**ANGEL PLACE
LEVEL 8, 123 PITT STREET
SYDNEY NSW 2000**

BETTY CUTHBERT DRIVE – RESPONSE TO POST-GATEWAY EXHIBITION COMMENTS

Subject **80 Betty Cuthbert Drive, Lidcombe Master Plan – Planning Proposal – Traffic and Transport Assessment Report Addendum**

Our reference MMD-405675-PP-TM-01

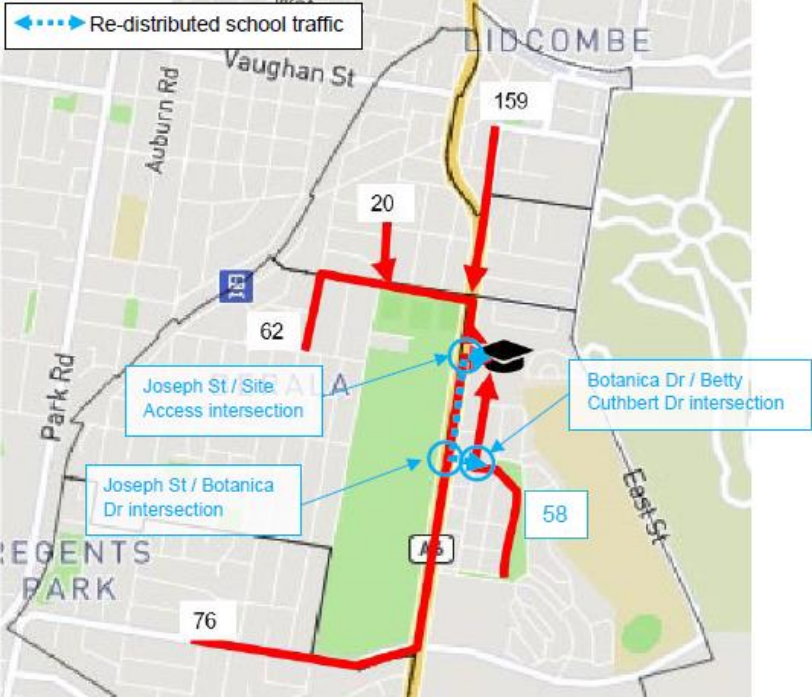
Council Comment	Response
<u>Traffic, Transport and Access</u>	
Provide information on the ability for Betty Cuthbert Drive to restrict access between the proposed school and the existing residential area	In response to Council's comments, a Technical Memo has been prepared by Mott Macdonald and is enclosed in Appendix A. From a traffic perspective it is not considered a positive outcome to constrain movements between the new local access street and Betty Cuthbert Drive for the following reasons: As noted in the Traffic and Engineering Report prepared as part of the Planning Proposal package, only 58 trips are anticipated from within the Botanica Estate during the AM Peak (refer to Figure 1). Restriction would require any trips from the south to be made via Joseph Street which would increase traffic movement along the sub-arterial. Figure 1 School Traffic Distribution - AM peak period  Source: Mott Macdonald (Appendix F – Traffic and Engineering Report)

Figure 1: Concept Indicative Layout Plan – Potential Measures to Restrict Traffic Movements on BCD

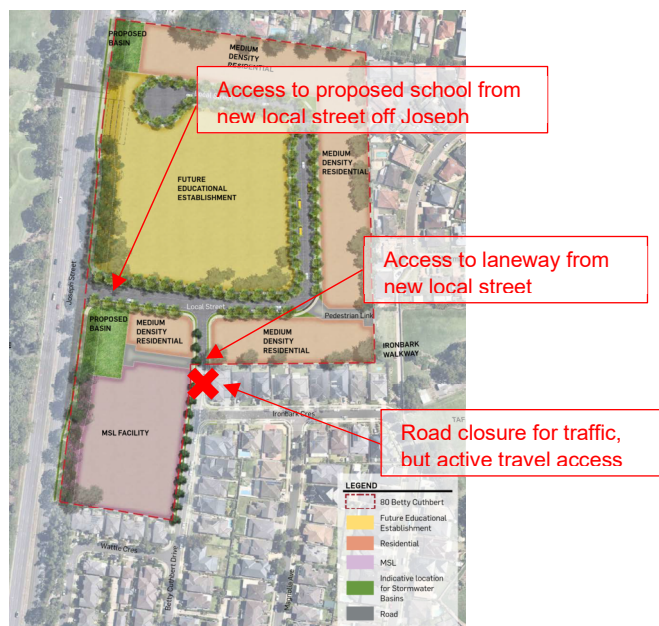
1. *Provide information on the ability for Betty Cuthbert Drive to restrict access between the proposed school and the existing residential area.*

This could be achieved by restricting vehicular access on BCD, south of the new local street, near its intersection with Ironbark Crescent. A connection should be maintained for active transport to ensure pedestrian network permeability, with a potential opportunity to convert the closed section into a shared path.

Such closure should be located south of the proposed laneway linked to the medium density residential component on the western side of BCD (see Figure 1). This would ensure that new trips to the site are made via the proposed new site access and local street. Trips to the Multiple Sclerosis Limited (MSL) facility would be retained along BCD as per the existing situation, noting however that users of this facility would be unable to use the new site access and local street to access it. It is also noted that, depending on the final location of the closure, a turnaround facility may be required to the south of it to allow vehicles on BCD to turn back.

Figure 2: Education Facility Traffic Distribution - AM peak period

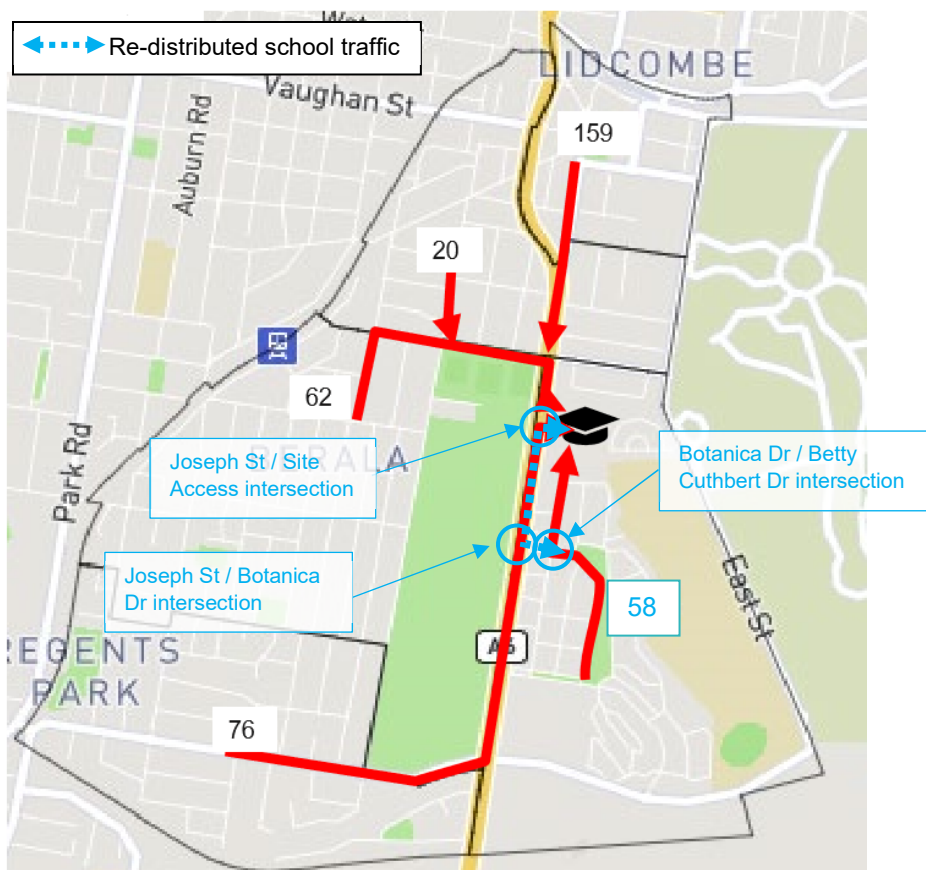
2. *Undertake further analysis to understand the implications from a traffic modelling perspective should traffic distribution be modified to access the proposed school. In particular Council is seeking to better understand the implications of redistribution of traffic generation from the existing Betty Cuthbert Drive via Joseph Street and the new access road to the proposed school, as well as the redistribution of traffic generation from the Berala area to Leila Street (where students and/or staff would use the proposed pedestrian overpass to access the proposed school).*

Traffic generating from the existing BCD is re-distributed to the proposed education facility via Joseph Street and the new access proposed for the education facility from Joseph Street. The traffic generated to / from BCD to education facility is 58 vehicles in the AM Peak. For the purpose of this modelling test, this traffic is diverted to / from Botanica Drive / BCD intersection to Joseph Street / Site Access intersection via Joseph Street / Botanica Drive intersection. An update to Figure 5.7 of the Traffic Report is included below in Figure 2 to highlight this change in traffic distribution.

The change in traffic distribution is limited to the three intersections highlighted in blue in the figure above. This change in flows would represent less than 2 % of the overall traffic travelling through each of the intersections on Joseph Street for that peak hour and scenario, which represents a lower value than daily fluctuations (generally considered to be within 10 %). Therefore, to better understand any potential change in intersection performance, the SIDRA models for these intersections have been run individually with the new flows.

Figure 6: Proposed Pedestrian Bridge – Typical Envelope Schematic (Ramp Option)

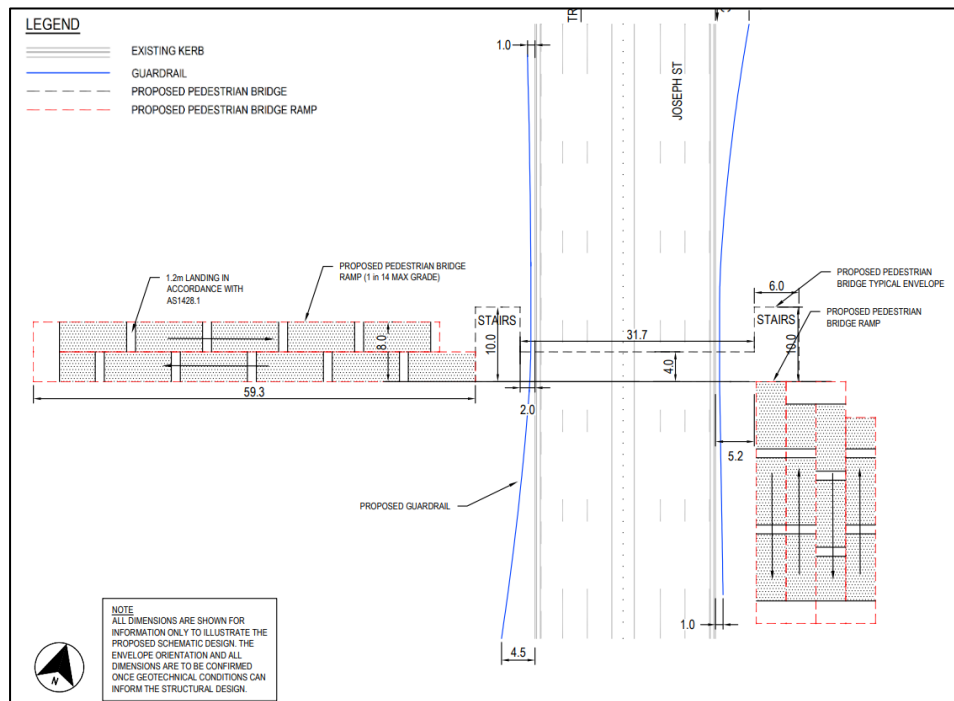
5. *Provide further information on the footprint required for the proposed pedestrian overpass for both sides of Joseph Street, as well as the location of new footpaths to access the proposed pedestrian overpass.*

Figure 6 shows a plan of the proposed pedestrian overpass and the footprint required. This is an extract from the plan included in Appendix B of the Traffic Report, which presents the typical envelope schematic.
